CITY OF DALLAS

RE: Appeal of Certificate of Appropriateness:
Hearing – October 3, 2022
4512-4518 Sycamore St., Case No. CA212-354(RD)

**4512-4518 SYCAMORE
STREET
APPEAL
CA212-354(RD)**

**City Plan Commission
Hearing
01/05/2023**

Duplex Number 2

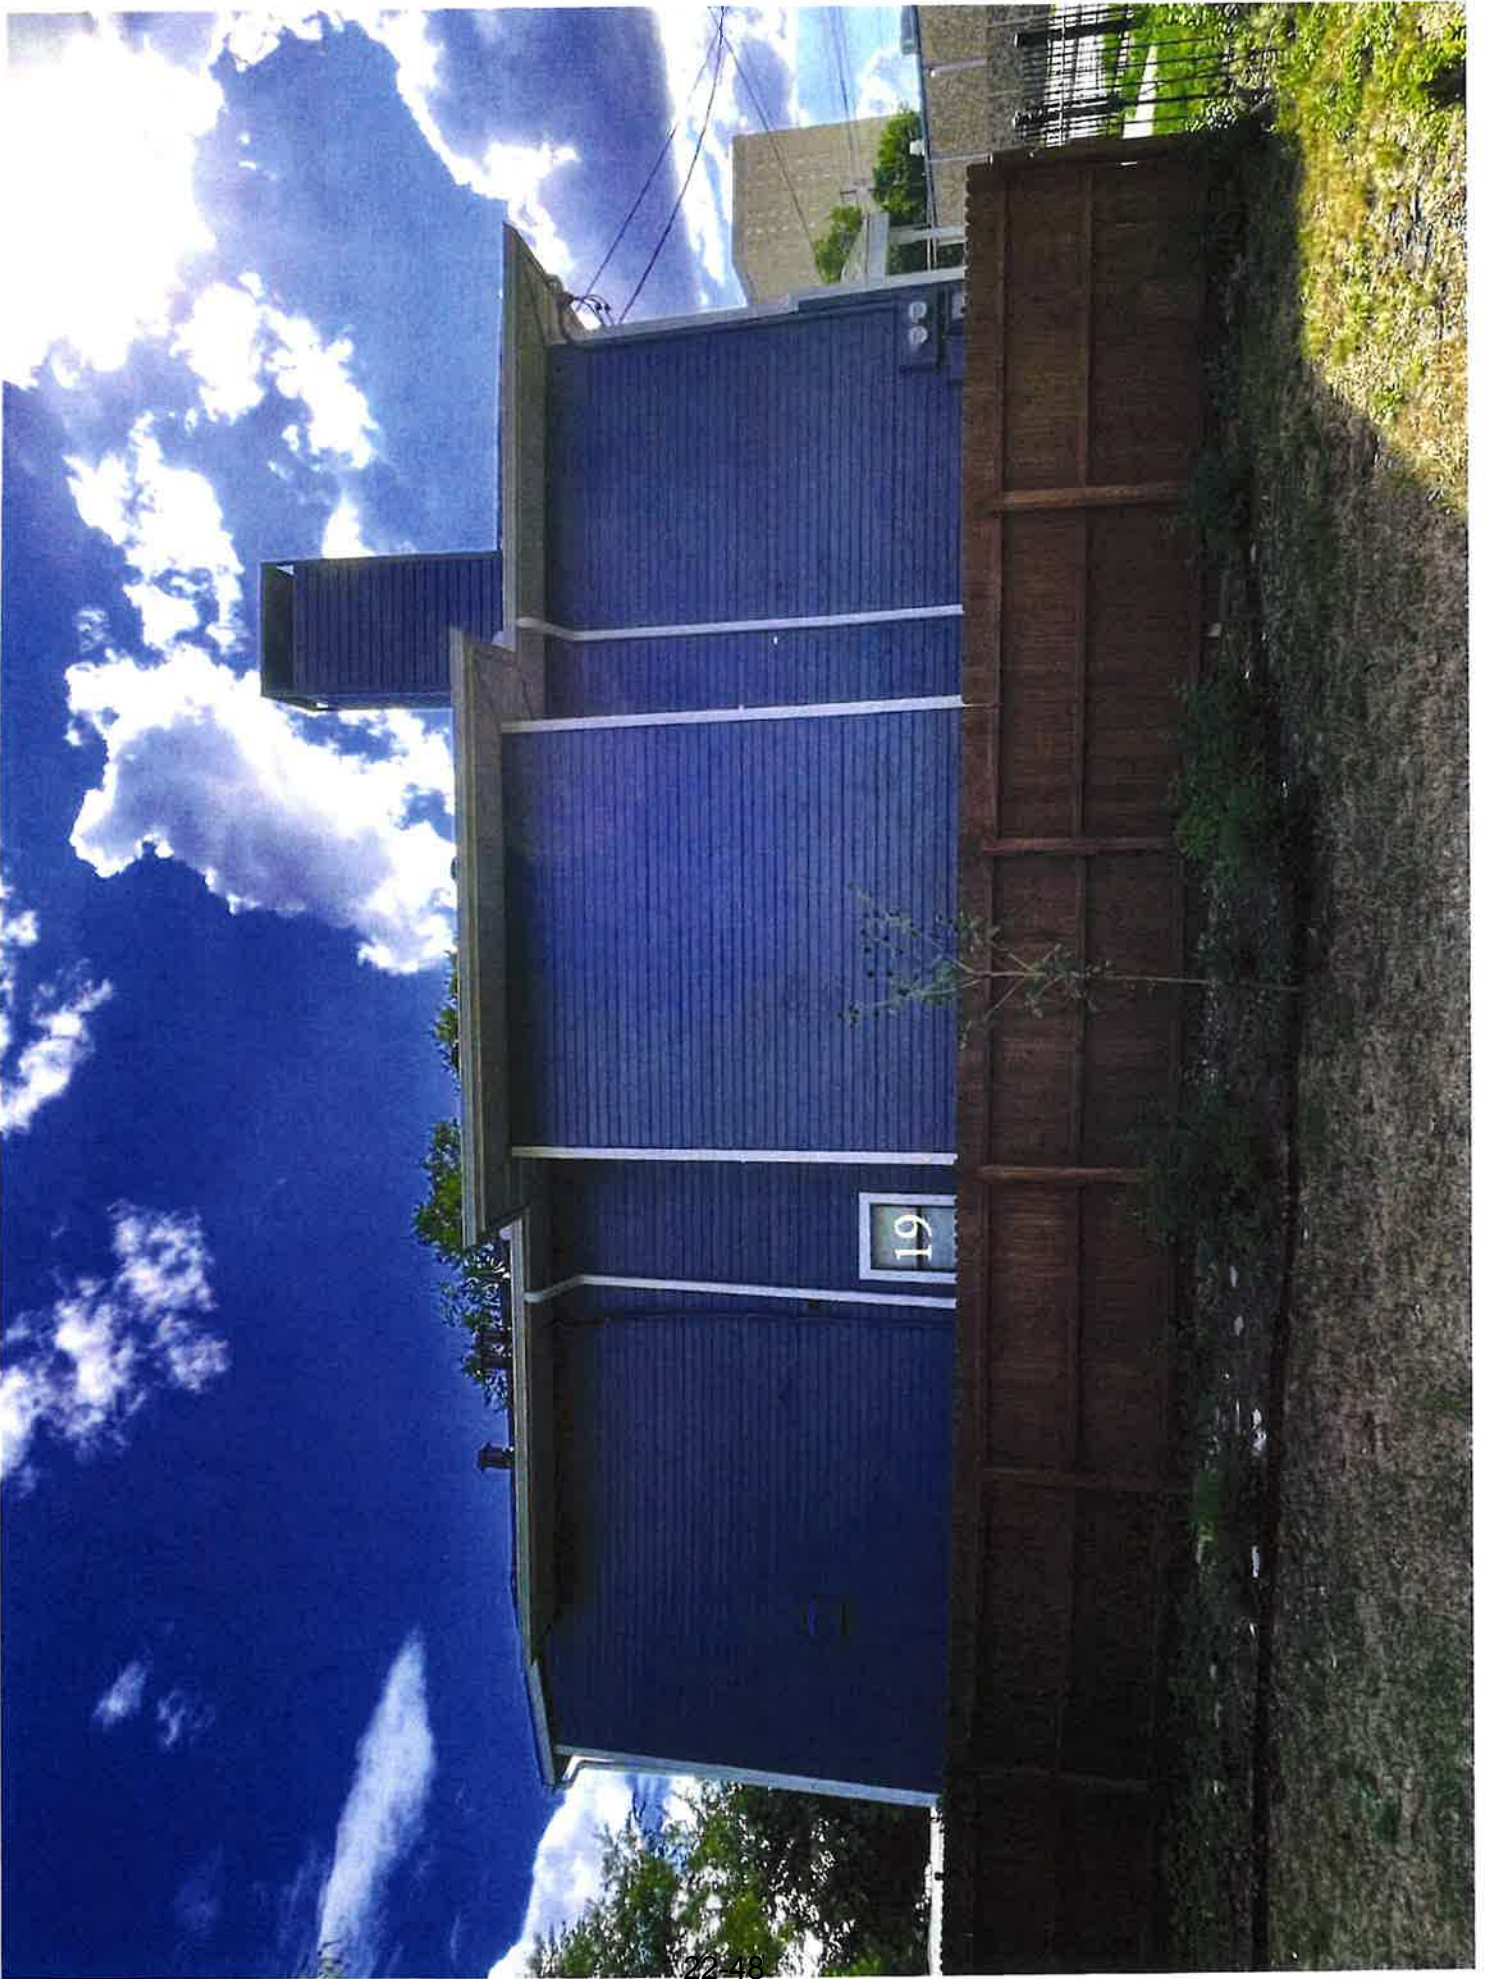
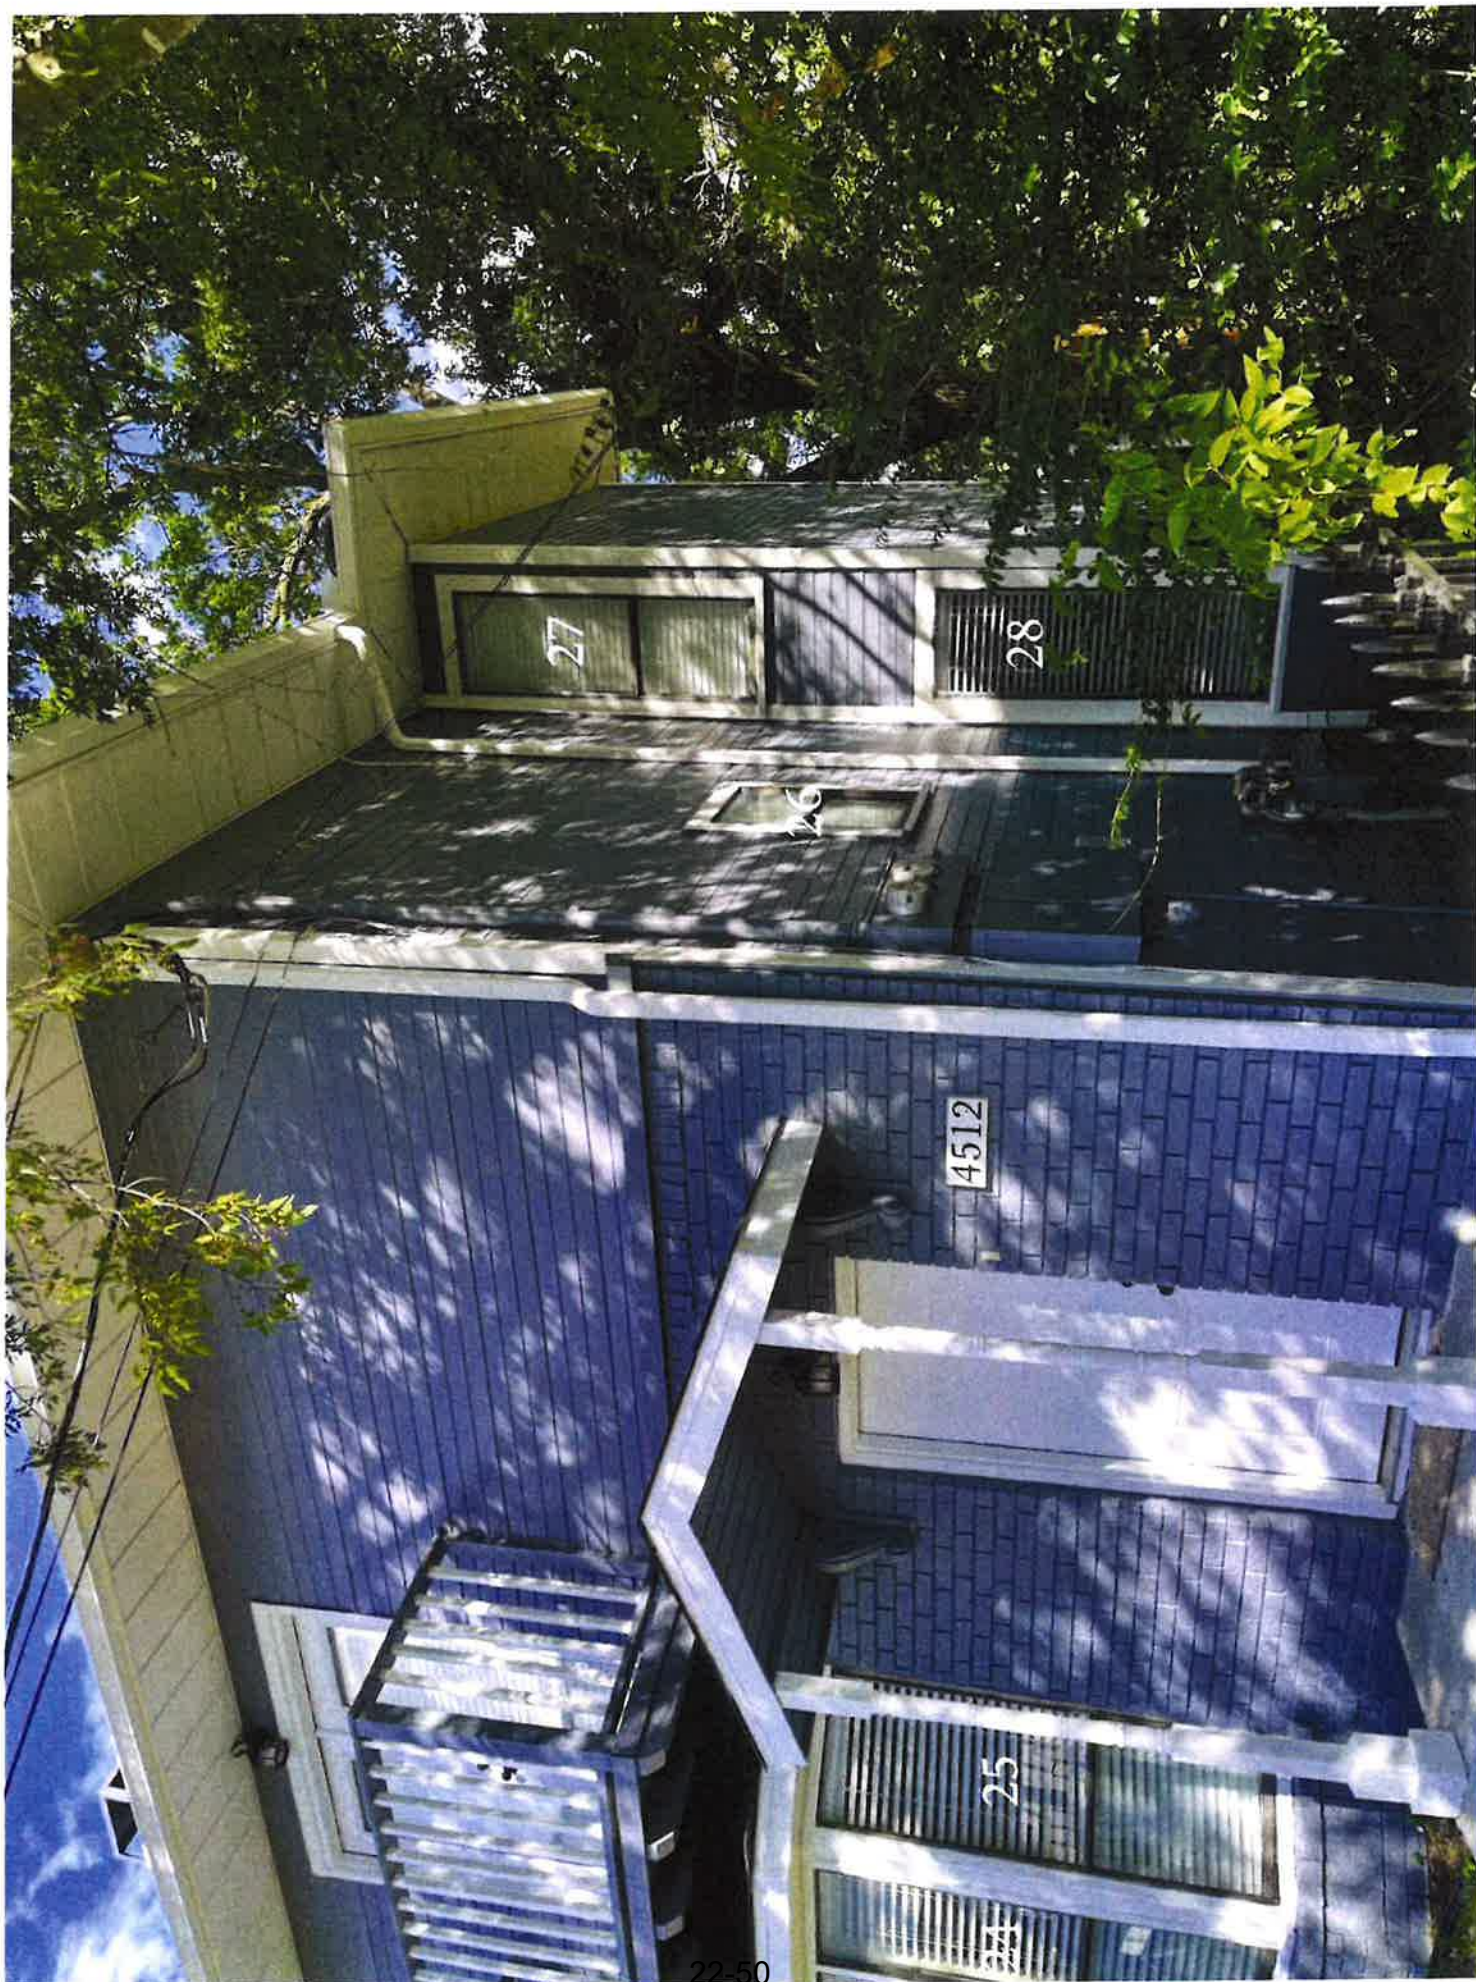
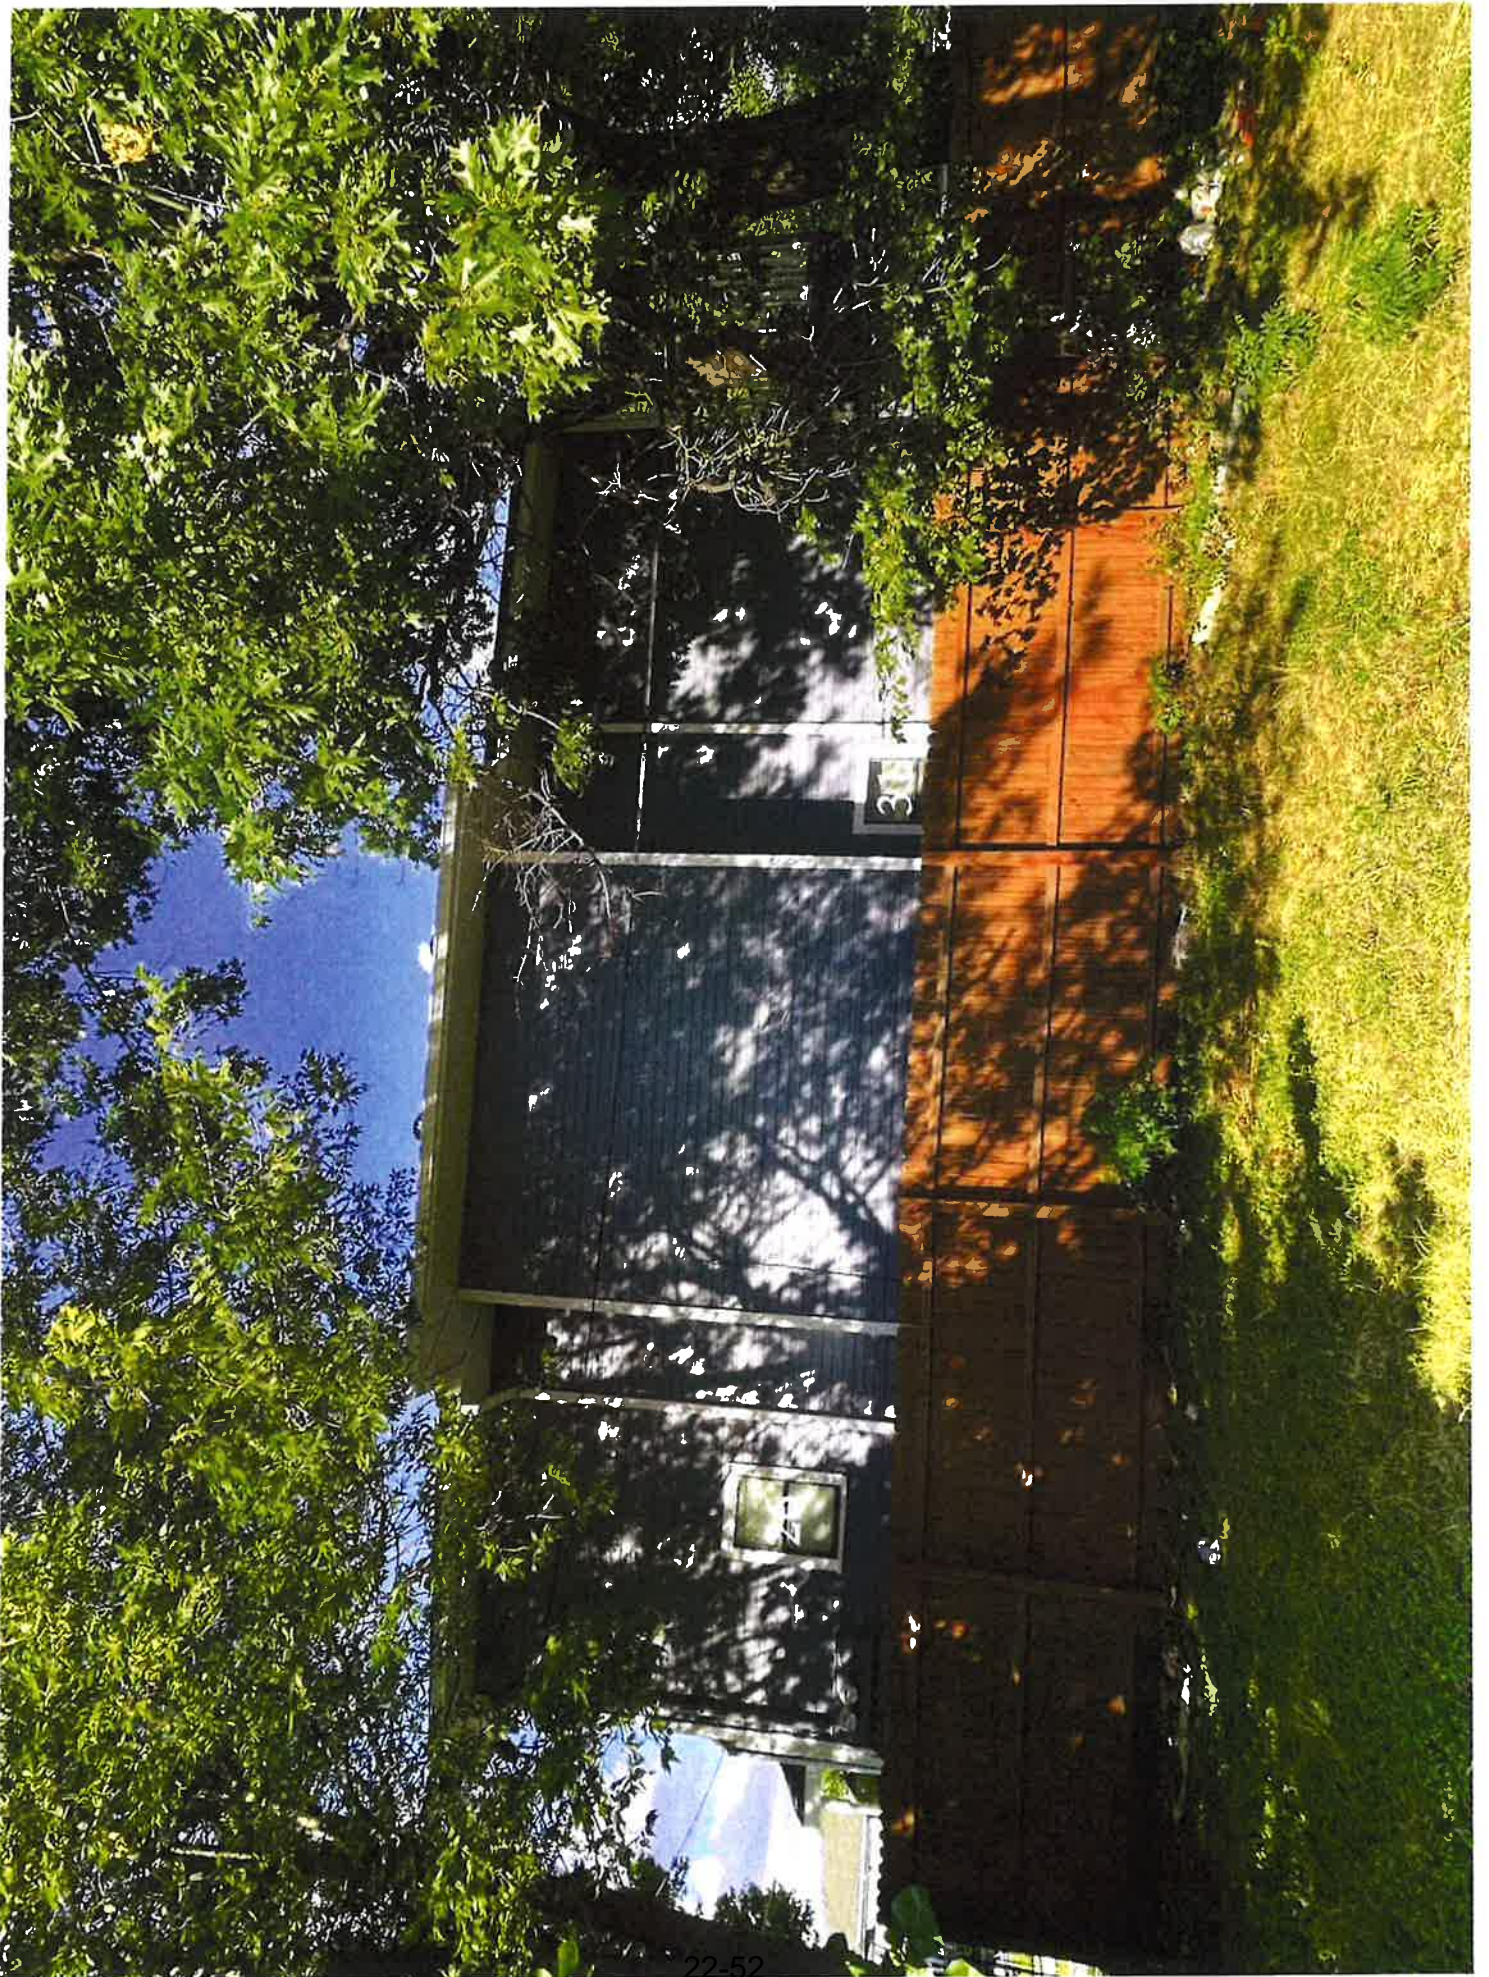
The applicant is proposing to replace aluminum sash windows (one over one) with wood composite windows, on both primary structures. Pictorial evidence shows the condition of the existing aluminum windows is poor. The applicant has not replaced the windows but has entered into a binding contract with Renewal by Andersen.

- 5) That the request for a Certificate of Appropriateness to replace aluminum windows with wood composite windows – thirty-one total (Brand: Andersen, Material: Fibrex®) be approved in accordance with specifications dated 9/1/22 with the following conditions: that the exterior innermost window frames be painted a complementary accent color; and that the lite configuration of the replacement windows be one over one (1 over 1). Implementation of the recommended conditions would allow the proposed work to be consistent with City Code 51A-4.501(g)(6)(C)(ii) for non-contributing structures, and the Secretary of the Interior's Standards.

SASH - EXPLODED VIEW

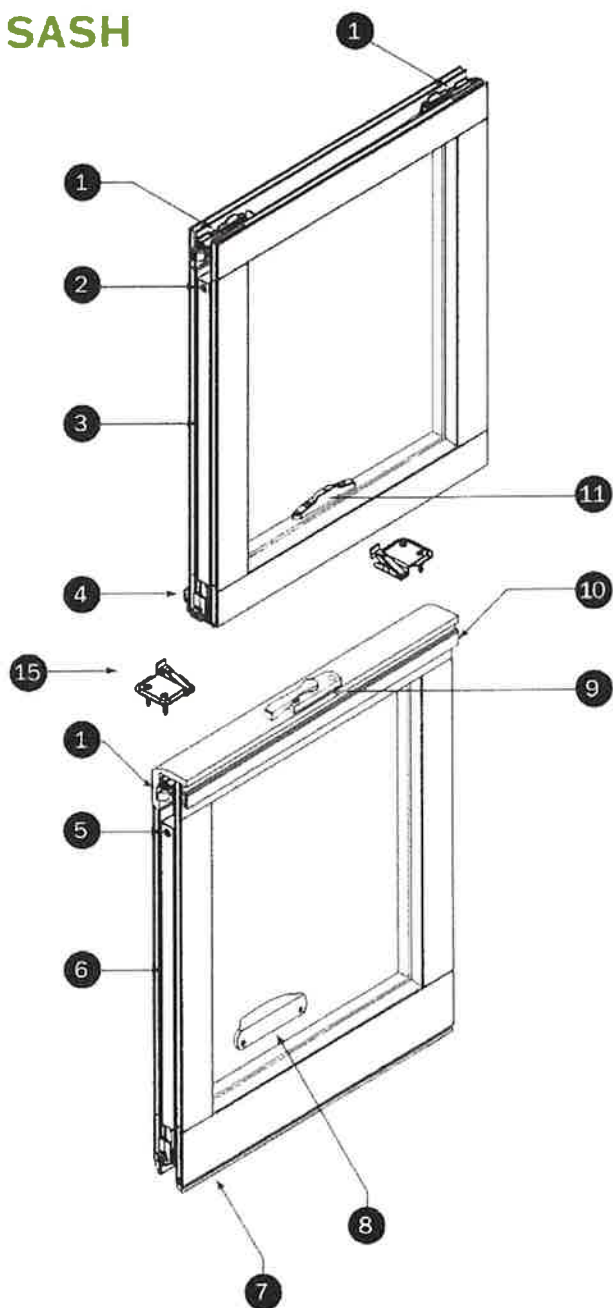
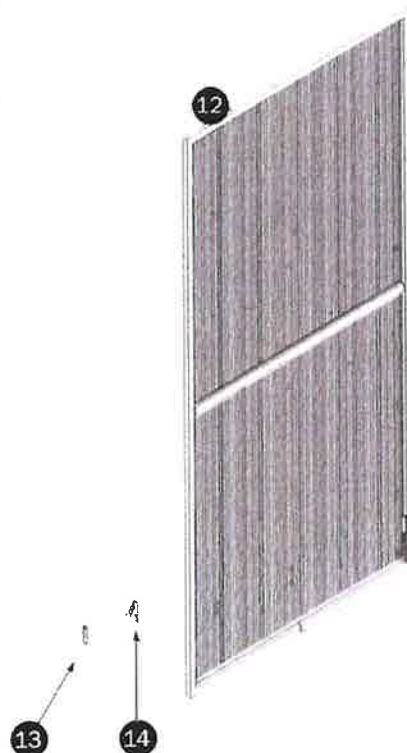
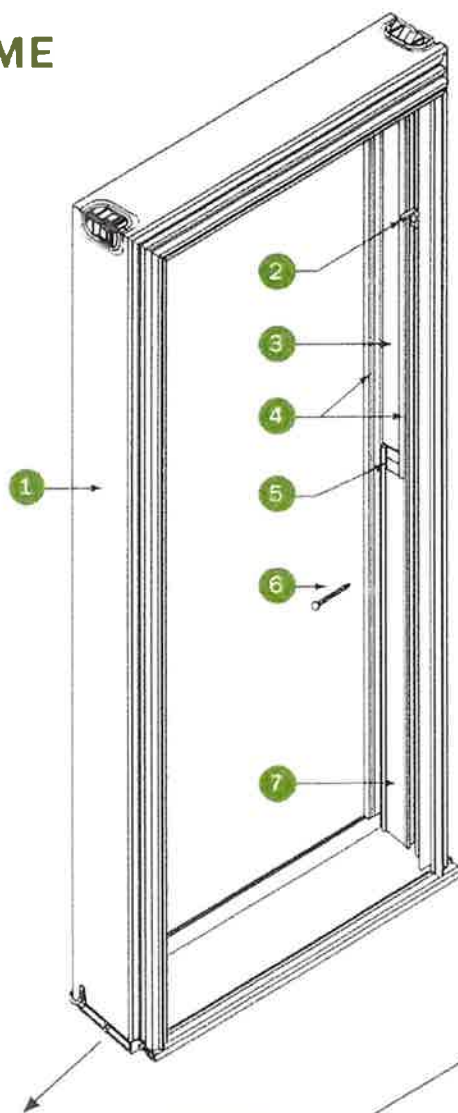
2 don't see on the detail that's provided
3 that -- it looks like the meeting sash
4 is the same dimension as the side rail
5 sashes and the top rail sashes. I don't
6 see a difference between your meeting
7 rail sash. That's a very prominent
8 feature on historical windows, interior
9 windows, and I don't see that.

14 COMMISSIONER CUMMINGS: No, I'm
15 talking about the bottom sash. There's
16 also indications of differences on the
17 thickness of the meeting sash, but let's
18 just talk about the bottom sash. What's
19 your dimension on your bottom sash? And
20 I also don't see a sill detail that was
21 called out, and you had three choices on
22 the windowsills.

11 COMMISSIONER CUMMINGS: Correct.
12 It doesn't seem like there's a
13 difference between the bottom sash
14 dimension and the side dimension.

5. That the request for a Certificate of Appropriateness to replace wood windows with wood composite windows be **denied**. Wood composition windows are not wood, and these windows would have an adverse effect on the historic district. Work is not consistent with 51A-4.501(g)(6)(c)(ii) for non-contributing structures. Proposed work is not compatible with the historic district.
